RE: Samaritan Hospital Site Plan Application -
Planning Commission Hearing March 20, 2014
Conceptual Review Comments

Please accept the following letter as the Applicant, St. Peter's Health Partners explanations, comments and position on the items documented in the working draft of the City review comments issued March 21, 2014.

TROY MFP PROJECT
 SAMARITAN CAMPUS
 2212 Burdett Ave.
 Troy, NY 12180

03-01 Sidewalks along Burdett Looking North

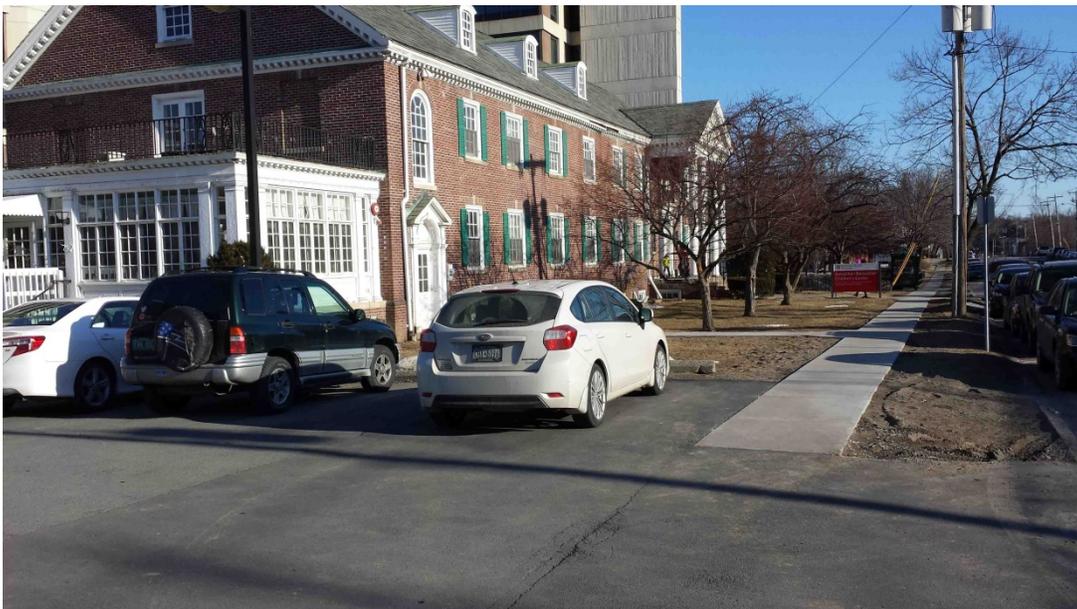
Comment 03:

All sidewalks should be at least 5' wide. Replace or expand smaller walks

Comment 03-4/16:

City standard for sidewalk width is 48", and depth is 6". Wherever walks are replaced owner will provide 4' minimum width. City engineer to review sidewalk construction details. Wherever curbs are replaced or constructed they will be granite per city standard.

The Applicant will be installing a new sidewalk along the south side of Eagle Street from the Corner of 17th Street to the sidewalk at the Samaritan Medical Office Building. The Applicant wants to encourage employees walking from the 17th Street surface parking lot to walk along the south side of Eagle Street and up to the new main hospital entrance. Limiting sidewalks on 17th Street will help to encourage this pedestrian movement pattern. No work is planned for the Peoples Avenue side of the campus. Work along Burdett is limited to adding new curbs and resurfacing the Hospital roadway entrance. Sidewalks in front of the Samaritan Day Care facility have been previously widened to 5'. The applicant will work with the City Engineers office to evaluate the sidewalks at the Burdett street entrance and new drop curbs will be constructed as part of the improvements planned for the Burdett street driveway. The balance of the walkways are not within the project area. See photograph 03-01.

Applicant agrees to the comment.

Figure 22-01

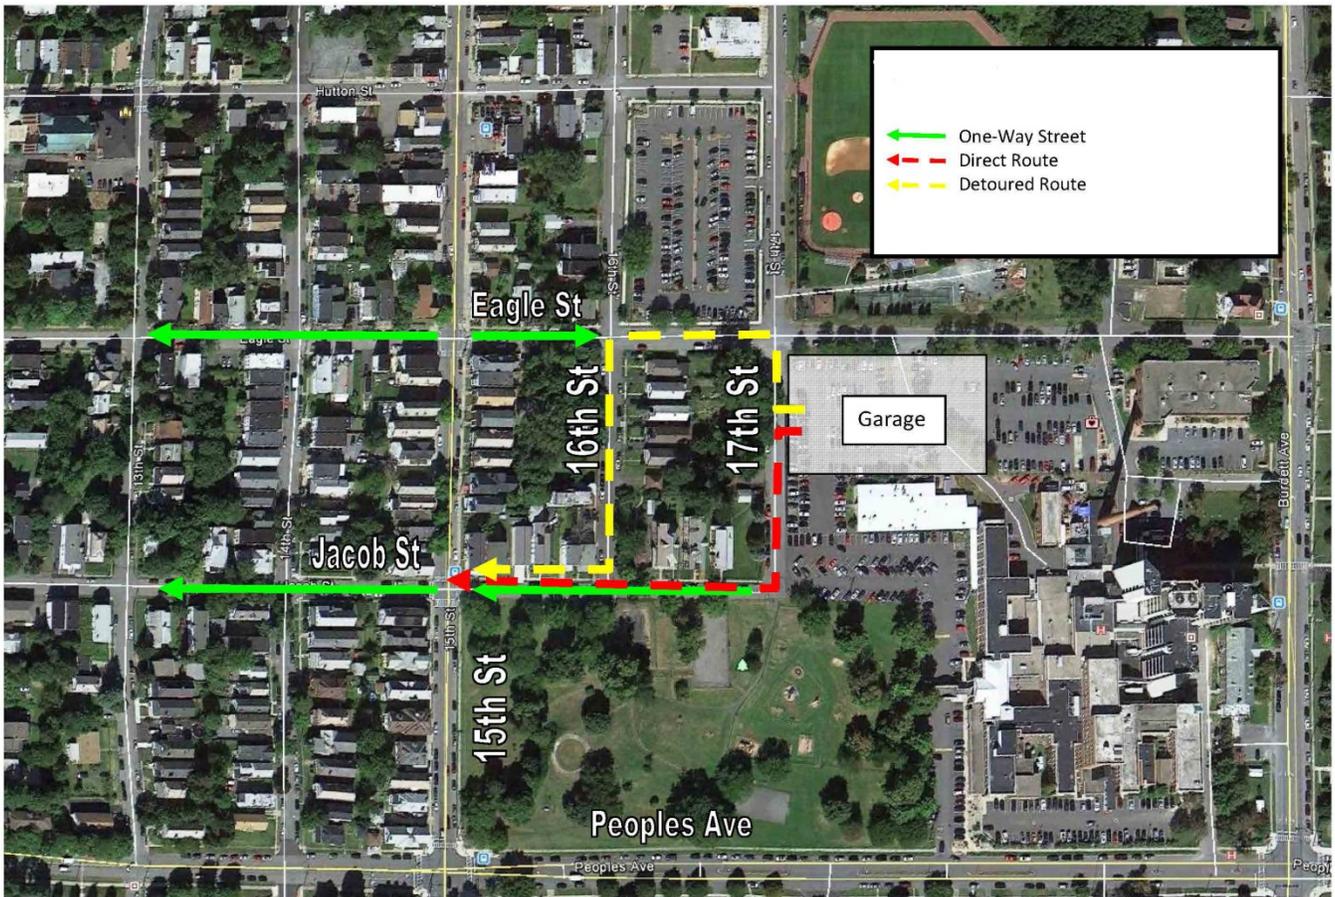
Comment 22:

Signage and curb configuration to force a right turn only out of the garage onto 17th.

Due to the existing one-way street configuration west of the hospital, drivers who are destined for points west or south of 15th Street, may affect a larger number of residences if lefts exiting the parking deck are restricted. For example, (refer to Figure 22-01) a driver who wants to travel south on 15th Street will turn left from the parking deck and right onto Jacob Street (red path). This route travels past 9 residences on Jacob Street before the intersection of 15th Street. With left turns restricted, a driver will follow the yellow path, traveling past 13 residences in total when driving south on 16th Street back to Jacob Street. Therefore, the restriction may simply displace traffic from one block to another with no significant benefit.

PROPOSED SIDEWALK IMPROVEMENTS

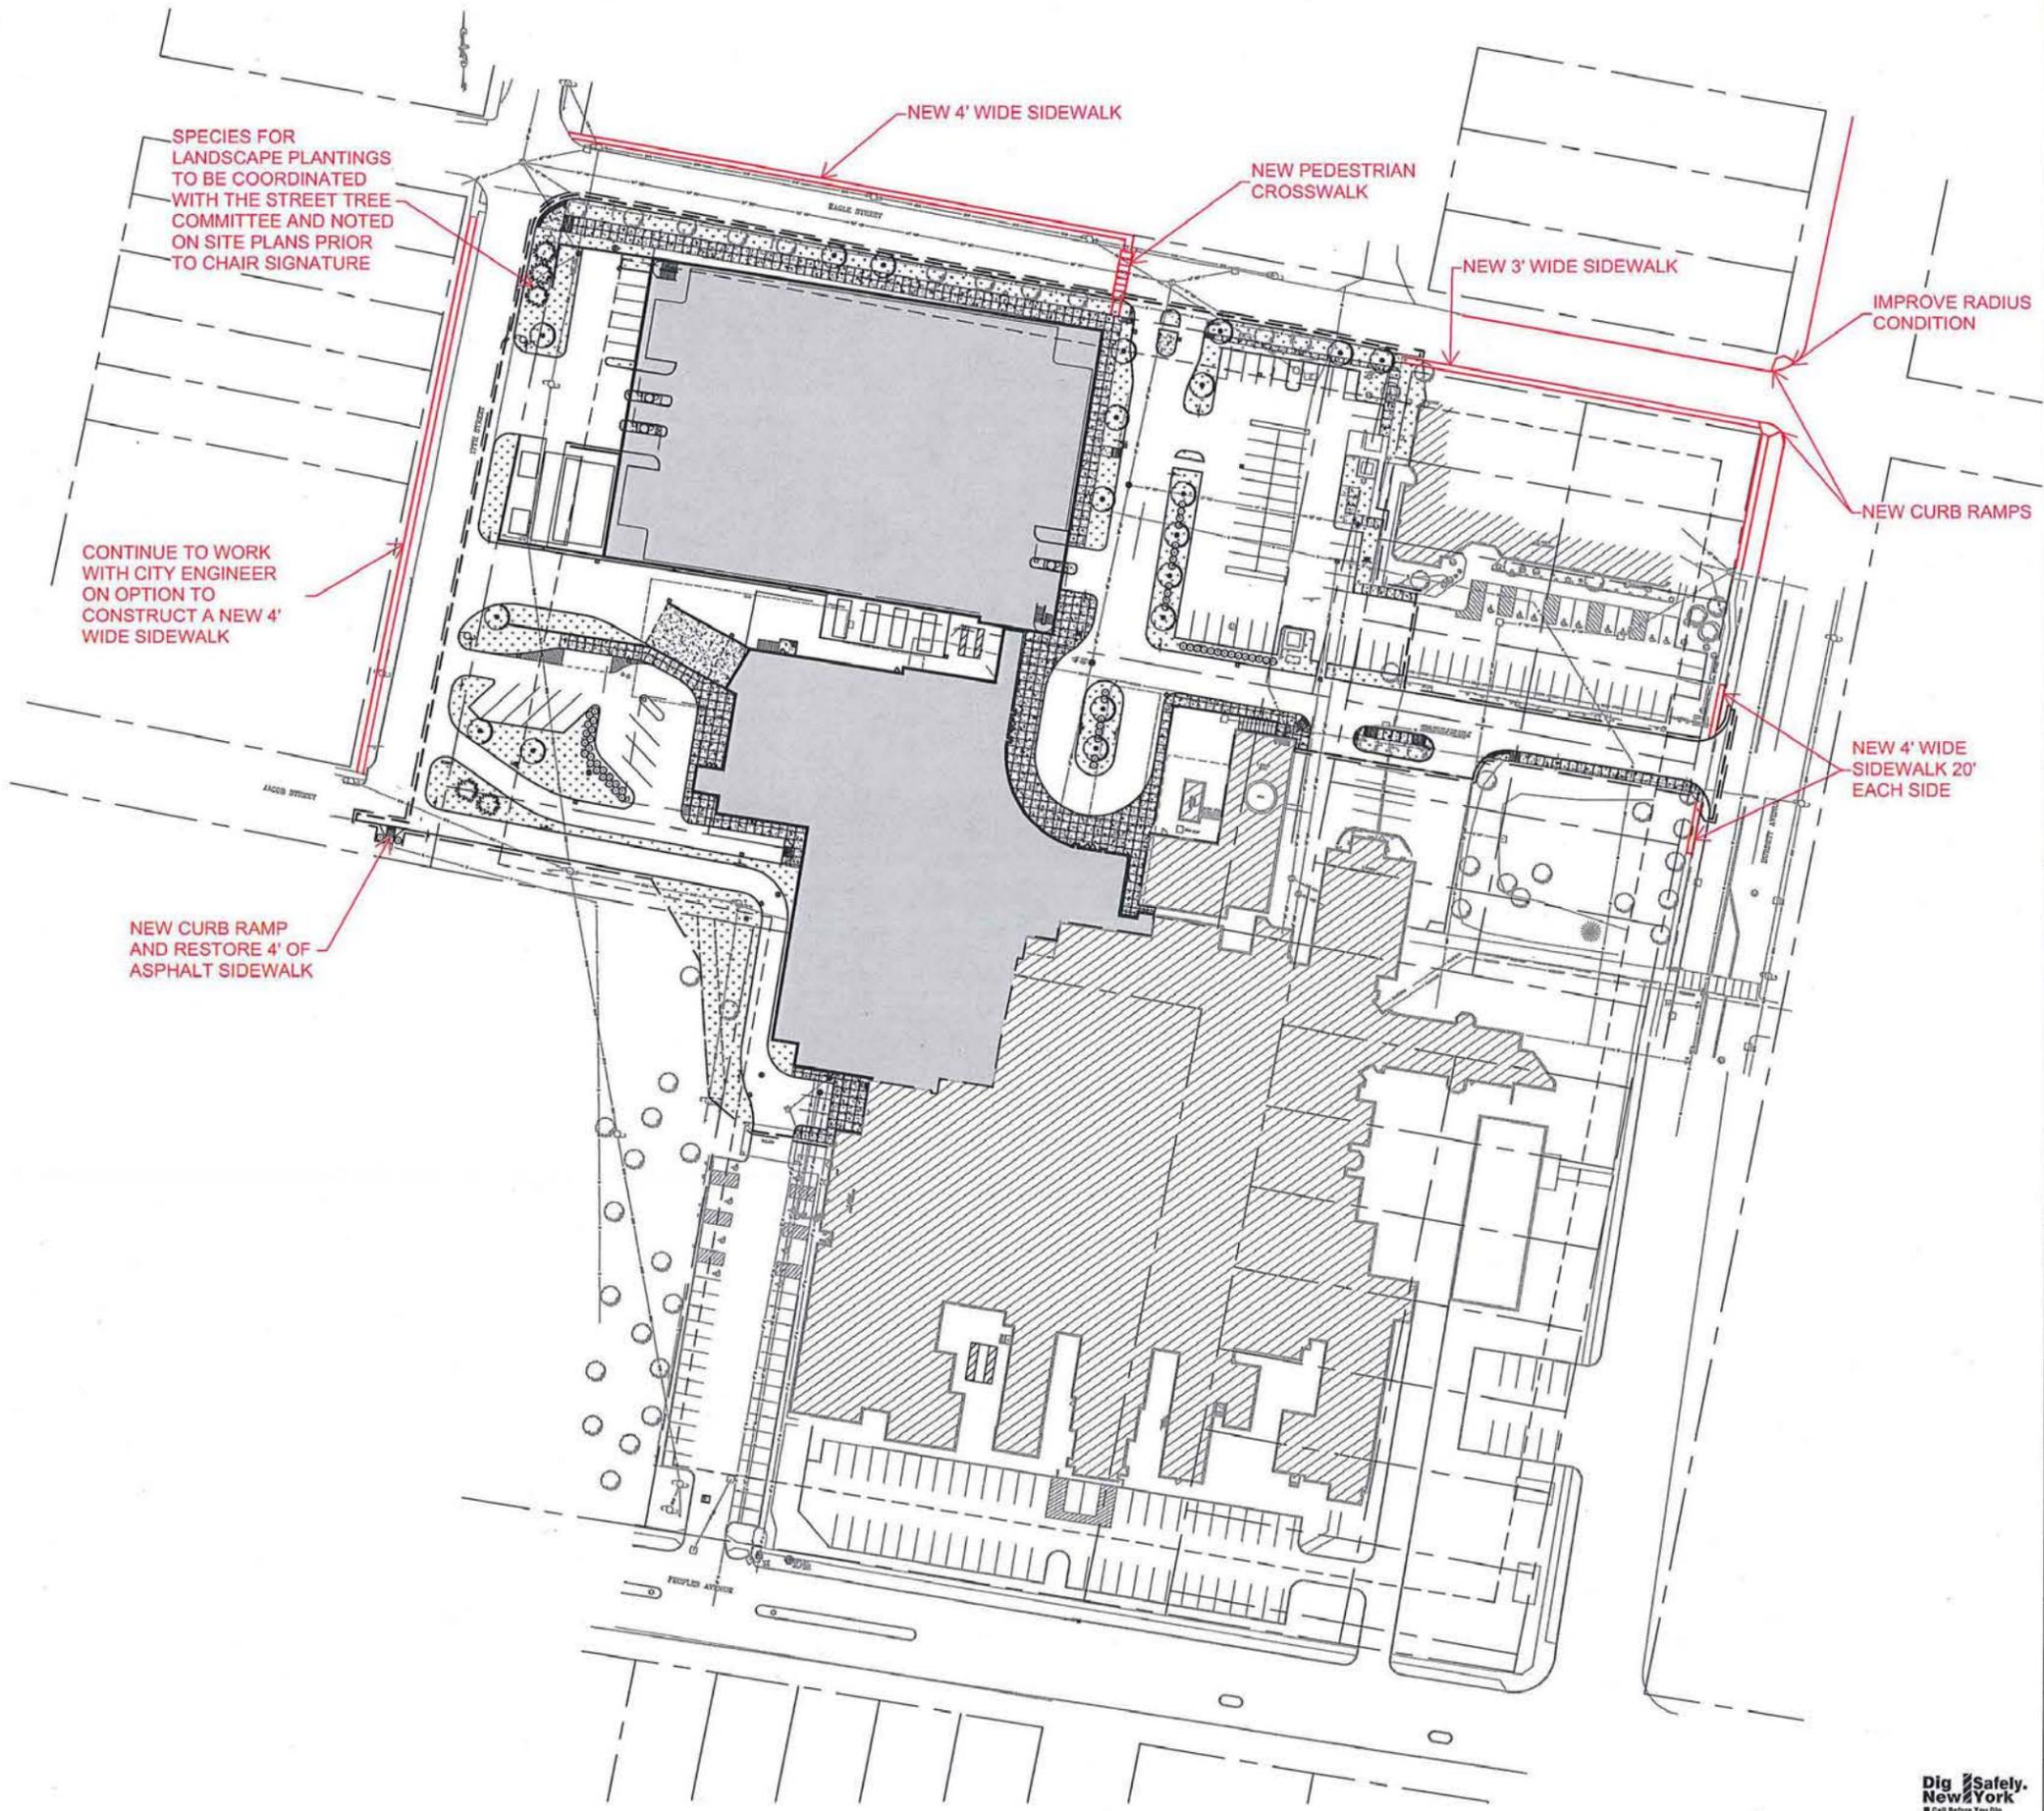
Comment 08:

Provide new sidewalk along full length Eagle with street trees and lighting

Comment 08-4/16:

Applicant agrees to add sidewalk from Eagle Street entry east to Burdett Avenue. Due to topography this sidewalk may need to be 3' wide instead of 4' minimum. New sidewalk will be installed on the north side of Eagle Street from 17th to a crosswalk at the Eagle Street entry. This is to provide safe access for employees parking in the "cage lot" while construction of the garage is underway.

Applicant agrees to the comment. Survey work has been completed and the additional sidewalk design is being added to the site plan drawings presented for Planning Chair signature following Final Site Plan approval. Please refer to the attached plan showing the location of all proposed additional sidewalks.

Applicant agrees to the comment and will investigate the need to move both utility poles with the caveat that any work requiring modification of the existing traffic signal is excluded from the scope of work anticipated related to this comment. Survey work has been completed and the design is being added to the site plan drawings to be presented for Planning Chair signature following Final Site Plan approval. Please refer to the attached plan showing the location of the proposed intersection improvements.

Survey work has been completed and the design is being added to the site plan drawings to be presented for Planning Chair signature following Final Site Plan approval. Please refer to the attached plan showing the location of the proposed ramped walkway, into the park.
